Access Compliance Report

Public Rights-of-Way

(Curb Ramps)

Intersection ID: 32275	Main Street: PRESCOTT_HILL_AV	Cross Street: SPRINGWELL_ST	Location: SW
ADA ID: BBB5463B432C	Ramp Type: Perp	Initial Pass/Fail: Fail	Overall Compliance: No
Severity Score: 12.5			
Codes/Mitigation Info/Possible Solution		Field Measurements/Component Compliance

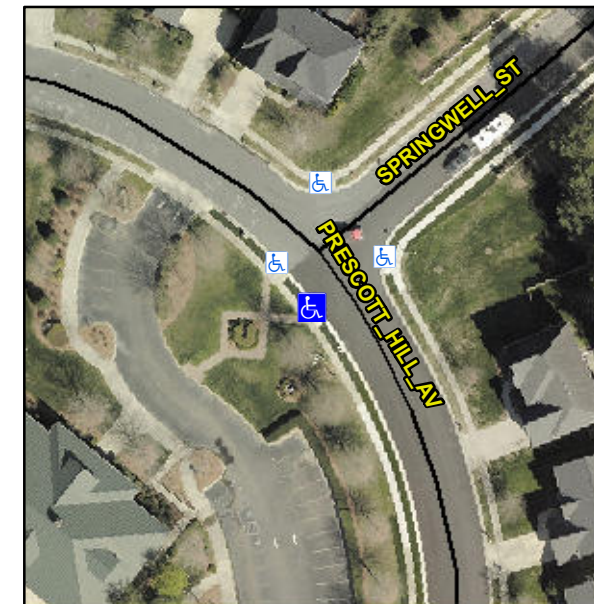
Not Found, R304.2.2

Compliance	Description	Data	Compliance	Description	Data
N/A	Ramp Length (in)	51.0	No	Ramp Slope (%)	10.5
Yes	Ramp Width (in)	63.0	Yes	Ramp XSlope (%)	0.6
N/A	Flare Type LT	N/A	N/A	Flare Type RT	N/A
N/A	Flare Slope LT (%)	N/A	N/A	Flare Slope RT (%)	N/A
N/A	Flare Traversable LT?	N/A	N/A	Flare Traversable RT?	N/A
N/A	Landing Length (in)	N/A	N/A	DWS Provided?	N/A
N/A	Landing Width (in)	N/A	N/A	DWS Contrast?	N/A
N/A	Landing Slope (%)	N/A	N/A	DWS Length (in)	N/A
N/A	Landing X Slope (%)	N/A	N/A	DWS Full Width?	N/A
N/A	Landing Curb? (Y/N)	N/A	N/A	DWS Offset (in)	N/A
N/A	Shared Landing?	N/A			
N/A	Gutter Ponding?	N/A	N/A	Gutter Slope (%)	N/A
N/A	Gutter Lip Ht (in)	N/A	N/A	Gutter X Slope (%)	N/A
N/A	Painted X Walk1?	No	N/A	Painted X Walk2?	N/A
	X Walk 1 Direction	To NE		X Walk 2 Direction	N/A
N/A	X Walk 1 Width (in)	N/A	N/A	X Walk 2 Width (in)	N/A
	X Walk 1 Slope (%)	5.4		X Walk 2 Slope (%)	N/A
	X Walk 1 X Slope (%)	0.2		X Walk 2 X Slope (%)	N/A

Remove & Replace Entire Ramp.
